## Tender Addendum

**Job No.:** 34754  
**Works:** Facade Improvement Works  
**Situate At:** Croydon College  
**Date:** 13/03/2023

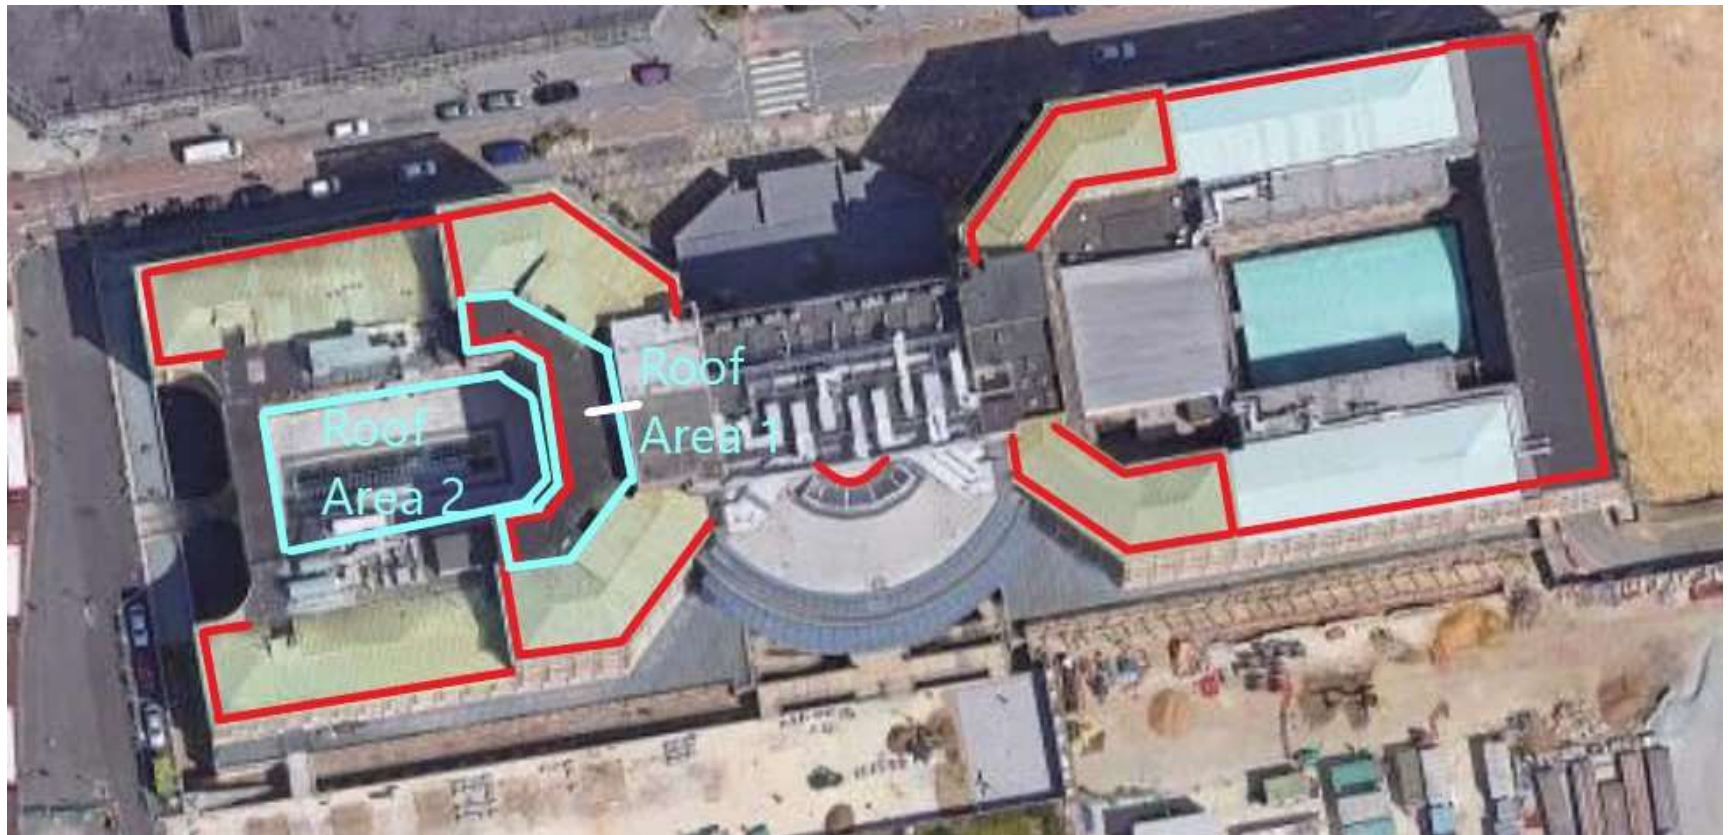
Section	Clause	Item	Cost
4	4.29	<p><b>New clauses added (4.29.1-4.29.12)</b></p> <p><b>Roof Replacement and Repair</b></p> <p>The proposed work consists of the replacement of flat roof coverings to Croydon College as identified on the attached plan. The contractor will be responsible for the full design, supply and installation of the works, which are to include the following:</p> <p>The full complete design of the new roof system, the supply and installation of new insulation and coverings etc, in compliance with Part L of the Building Regulations.</p> <p>The replacement of any rooflights, windows and doors impacted by the proposed work. Replacement of roofline goods on a like for like basis and refurbishment of gutters.</p> <p>Lifting and relaying or replacement of copings and associated works to lightning conductor systems. New lightning conductor systems, including provision of a lightning protection survey.</p> <p>The temporary removal of certain services (e.g. air condition units, extract ventilation) and their reinstatement on completion of the work.</p> <p>The installation of new edge protection system as highlighted on attached plan.</p> <p>The design and undertaking of a number of isolated repairs to other roof coverings to the college as described below and highlighted on the attached plan.</p> <p>The design, supply and installation of full, safe access provision to undertake the above works.</p>

4	4.29.8	The contractor is to design, supply and install a suitable edge protection system to roof areas 1 and 2 as well as the additional areas required as indicated on the attached plan.	
4	4.29.9	The contractor is to note the outlet for a number of roofs discharges internally within the school building. The contractor is to allow for a full CCTV survey of all roof outlets at the site, including for the provision of a report, which captures any recommendations for any remedial works.	
4	4.29.10	The contractor is to allow for the refurbishment of existing gully's/gutters as shown on attached plan. The contractor is to design, supply and install a new reinforced cold applied liquid overlay system to all areas, ensuring suitable termination detail in accordance with selected manufacturers requirements. The new system is required to have a minimum 10-year insurance backed guarantee.

4	4.29.11	The control is to allow to clear and jetwash through all rainwater outlets at roof level throughout the site.	
Section	Clause	Item	Cost £
4	4.29.12	The contractor is to undertake a number of isolated repairs to the locations indicated on the attached plans. The contractor is to allow for access to the each of the areas for full surveying, scheduling out and the full design of the repair to each of the following locations:	
		Repair 1 – Welding Roof – Ground Floor Level	
		Repair 2 – IT Plant – 3 <sup>rd</sup> Floor Level	
		Repair 3 – Paint Workshop – Ground Floor Level	
		Repair 4 – MIS Guttering/Gulley – 3 <sup>rd</sup> Floor Level	
		Repair 5 – Plant Roof (Archive Exit) – 4 <sup>th</sup> Floor Level	
		Repair 6 – Guttering/Gulley – 3 <sup>rd</sup> Floor Level	
		Repair 7 – Room 426 Leak – 4 <sup>th</sup> Floor Level	
		Repair 8 – Principal Balcony – 3 <sup>rd</sup> Floor Level	
		Repair 9 – Rotunda Roof – Ground Floor Level

Repair 10 – East End Gutter/Gulley – Ground Floor Level	
		Repair 11 – Room 280 Leak – 2 <sup>nd</sup> Floor Level	
		The contractor is to allow a provisional sum of £20,000.00 for the above repairs, only to be expended by the Contract Administrator.

- Roof Areas for Replacement
- New Guardrail Proposed

-  Gutters to be Refurbished
-  Roof Repairs at per Tender Addendum 4.29.11
